Access Compliance Report

Public Rights-of-Way

(Curb Ramps)

Intersection ID: 11102	Main Street: TUCKASEEGEE_RD	Cross Street: JAY_ST	Location: SE
ADA ID: 6E478F8B3C07	Ramp Type: PerpDiag	Initial Pass/Fail: Fail	Overall Compliance: No
Codes/Mitigation Info/Possible Solution		Field Measurements/Component Compliance	
Severity Score: 13.75

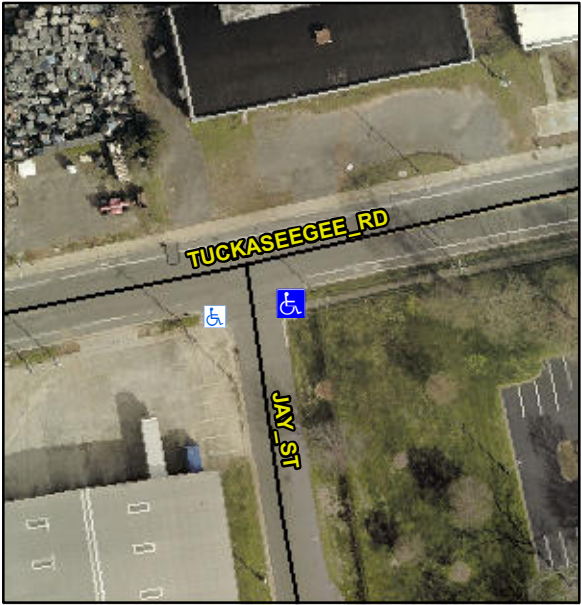
Possible Solutions:	Compliance	Description	Data	Compliance	Description	Data
	Remove & Replace Curb Ramp With Two New Directional Ramps or Equivalent.	N/A	Ramp Length (in)	60.0	No	Ramp Slope (%)	9.3
		Yes	Ramp Width (in)	48.0	No	Ramp XSlope (%)	3.9
		N/A	Flare Type LT	N/A	N/A	Flare Type RT	N/A
		N/A	Flare Slope LT (%)	N/A	N/A	Flare Slope RT (%)	N/A
		N/A	Flare Traversable LT?	N/A	N/A	Flare Traversable RT?	N/A
		N/A	Landing Length (in)	N/A	N/A	DWS Provided?	N/A
		N/A	Landing Width (in)	N/A	N/A	DWS Contrast?	N/A
		N/A	Landing Slope (%)	N/A	N/A	DWS Length (in)	N/A
		N/A	Landing X Slope (%)	N/A	N/A	DWS Full Width?	N/A
		N/A	Landing Curb? (Y/N)	N/A	N/A	DWS Offset (in)	N/A
		N/A	Shared Landing?	N/A			
		N/A	Gutter Ponding?	N/A	N/A	Gutter Slope (%)	N/A
		N/A	Gutter Lip Ht (in)	N/A	N/A	Gutter X Slope (%)	N/A
		N/A	Painted X Walk1?	No	N/A	Painted X Walk2?	No
			X Walk 1 Direction	To N		X Walk 2 Direction	To W
		N/A	X Walk 1 Width (in)	N/A	N/A	X Walk 2 Width (in)	N/A

X Walk 1 Slope (%)	0.7		X Walk 2 Slope (%)	5.1
			X Walk 1 X Slope (%)	6.0		X Walk 2 X Slope (%)	1.7
		N/A	Ramp inside XWalk1?	N/A	N/A	Ramp inside XWalk2?	N/A
<p>Surveyor Notes:</p> <p>N/A</p> <p>PROW/ADA:</p> <p>Not Found, R304.2.2, R304.5.3</p>			Road Slope (%)	3.7	N/A	Clear Space?	N/A
			Road X Slope (%)	2.3	N/A	Clear Space to XWalk (in)	N/A
		N/A	Any Obstructions?	N/A	N/A	Storm Grate/Utility Hazard?	N/A
			Obstruction Type			Storm Grate/Utility Type	
				N/A			N/A
					Yes	Surface Condition? (G/P)	Good
